FLYING HORSE NORTH FILING NO. 1  
COUNTY OF EL PASO, STATE OF COLORADO  
CONSRTUCTION DRAWINGS  
DECEMBER 2017

FLYING HORSE NORTH FILING NO. 1  
STREET IMPROVEMENT PLAN  
STAGECOACH ROAD  
STA. 15+00.00 - STA. 30+00.00

STAGECOACH ROAD  
(80' ROW - MINOR COLLECTOR)  
DESIGN SPEED 40 MPH

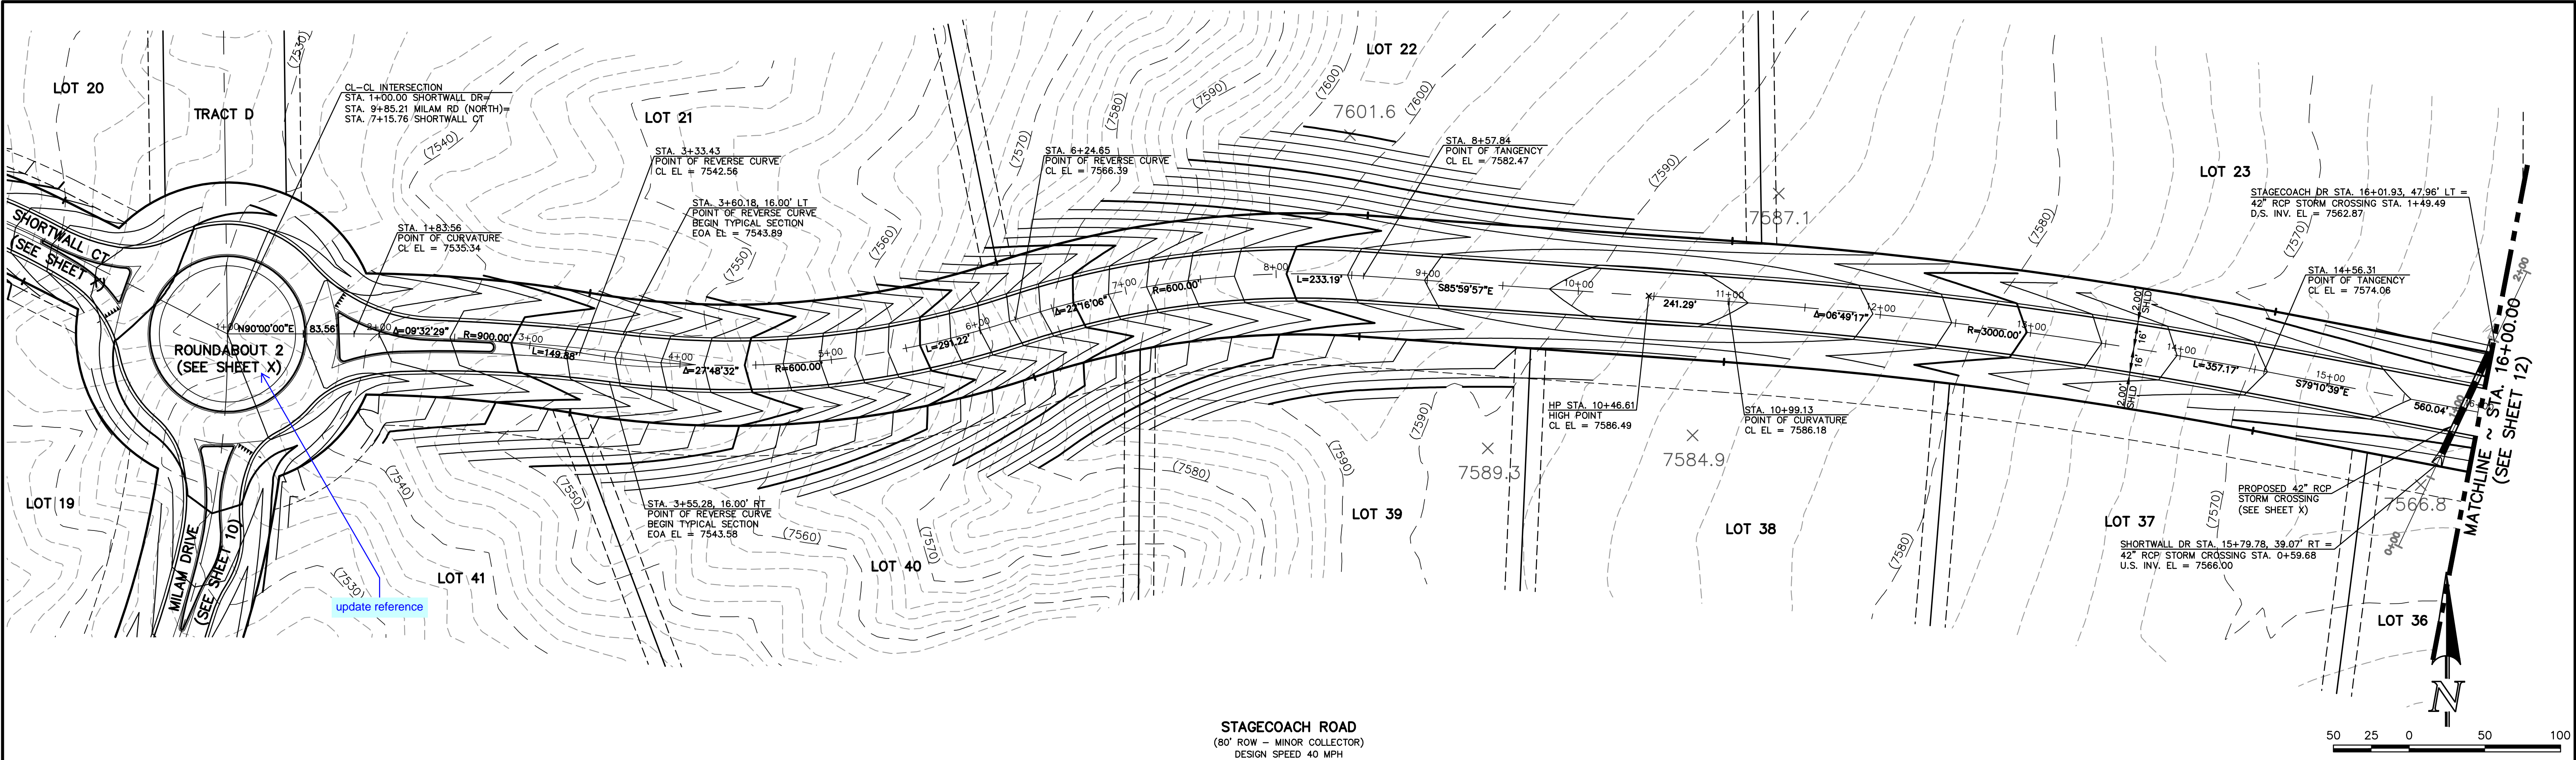
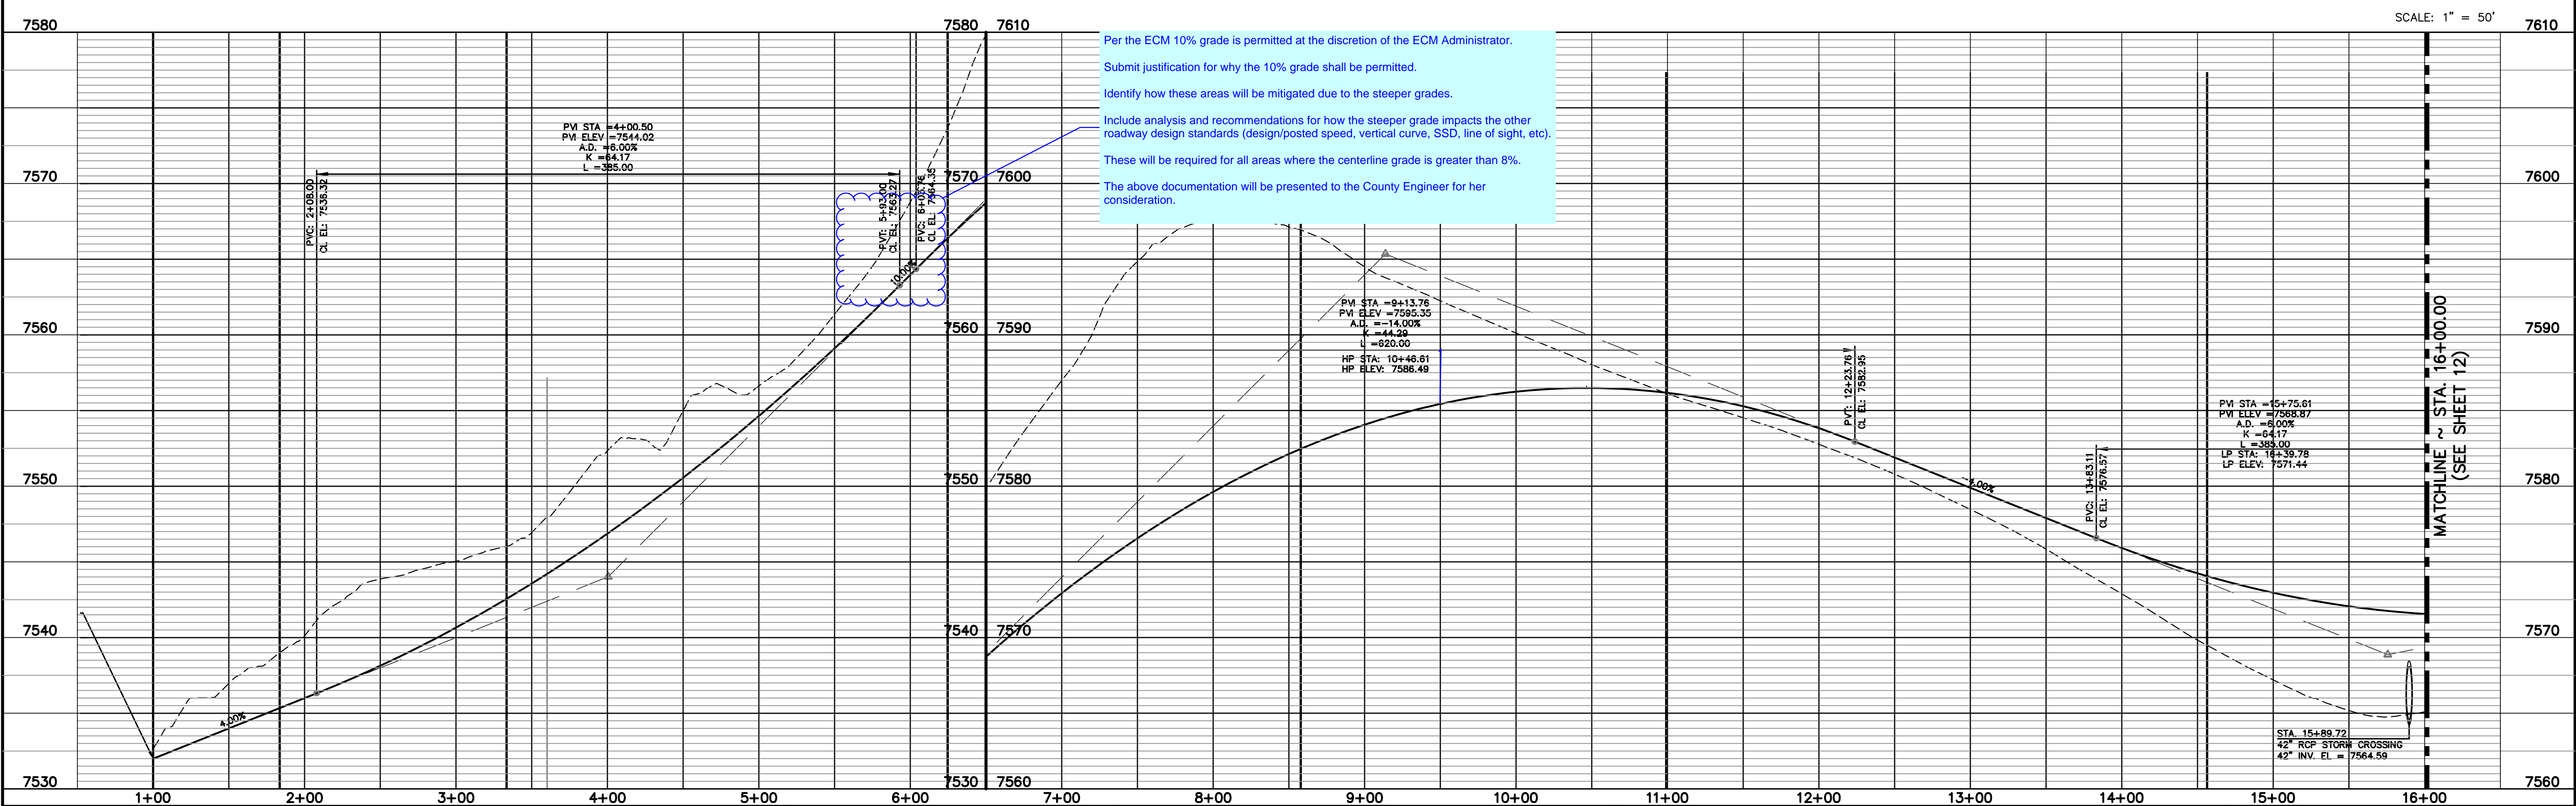
Per the ECM 10% grade is permitted at the discretion of the ECM Administrator.  
Submit justification for why the 10% grade shall be permitted.  
Identify how these areas will be mitigated due to the steeper grades.  
Include analysis and recommendations for how the steeper grade impacts the other roadway design standards (design/posted speed, vertical curve, SSD, line of sight, etc).  
These will be required for all areas where the centerline grade is greater than 8%.  
The above documentation will be presented to the County Engineer for her consideration.

FLYING HORSE NORTH FILING NO. 1  
STREET IMPROVEMENT PLAN  
SHORTWALL CT (STA. 0+00.00 - STA. XX+00.00)  
RUBBLE DR (STA. 0+00.00 - STA. XX+00.00)

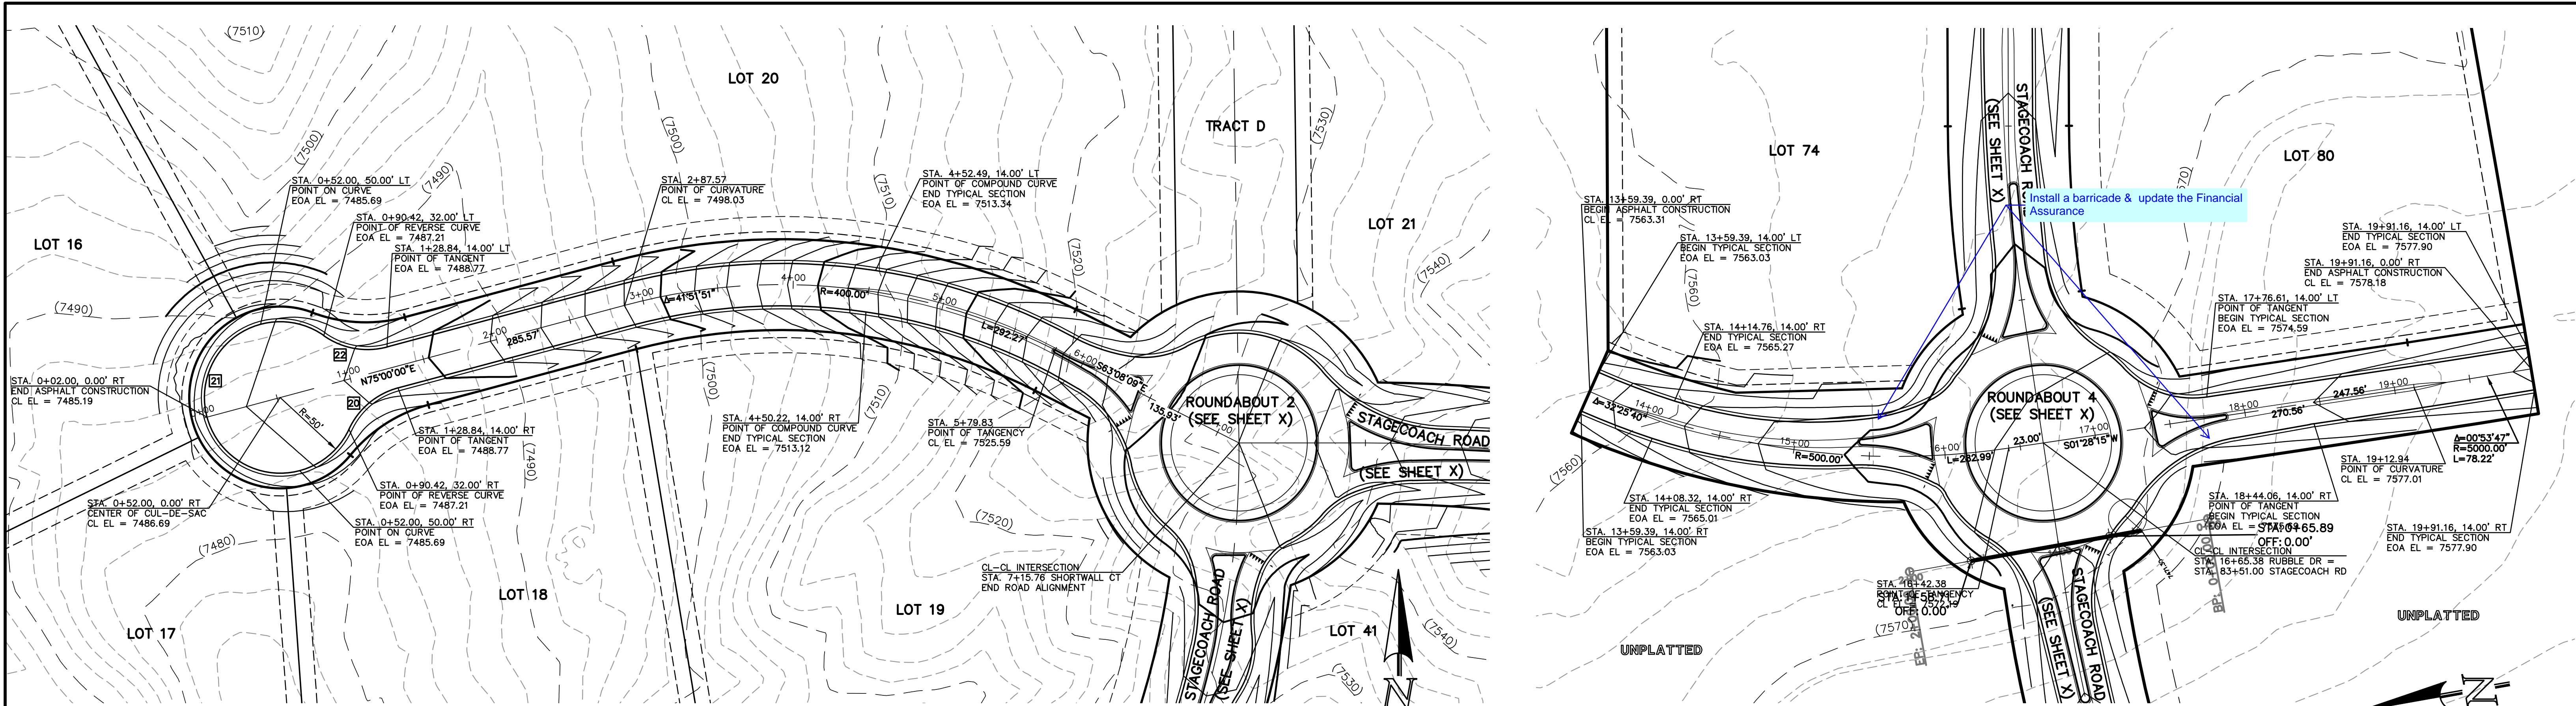
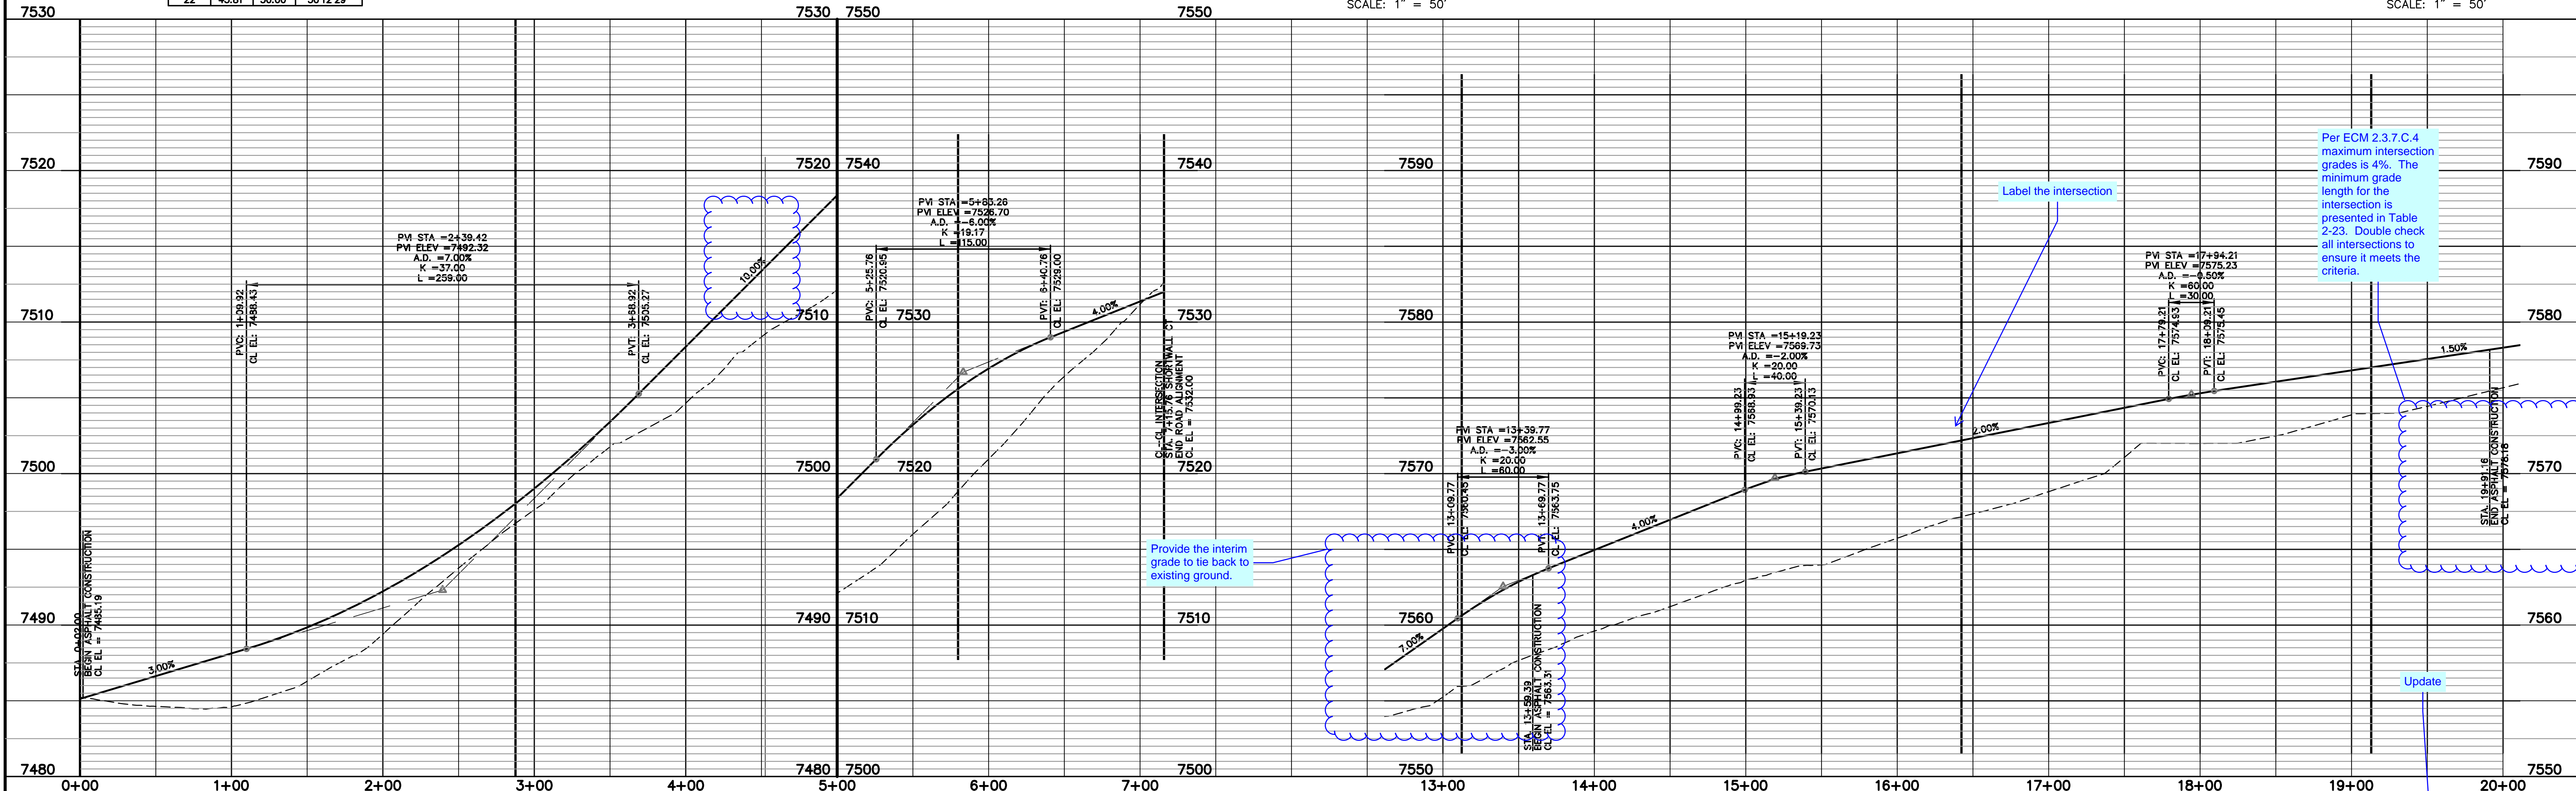
Per ECM 2.3.7.C.4 maximum intersection grades is 4%. The minimum grade length for the intersection is presented in Table 2-23. Double check all intersections to ensure it meets the criteria.

Provide the interim grade to tie back to existing ground.

Label the intersection
